The following is a clarification for RFB #8365 in question and answer form.

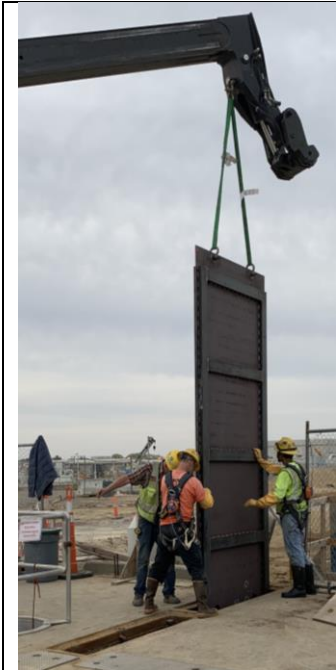
2Q) With the tight tolerances on your sliding Gates, can you explain in more detail how these work and function? also possibly provide pictures of existing structure at sliding surface if available?

2A) Staff will manually drop these gates into channels in order to block flow in specific channels and force it to only go through other channels. Oftentimes staff will perform maintenance downstream of these channels. During such operations the gate will have a full load of water on one side of the gate. We can't have much water leak by when a gate is fully seated in its slot. See pictures at the end of this document. Functionally the gates only sit about an inch into the gate guides. In fact, the test gate we used to determine the final dimensions actually hit the weld toe on the edge stiffener where the weld was larger than specified.
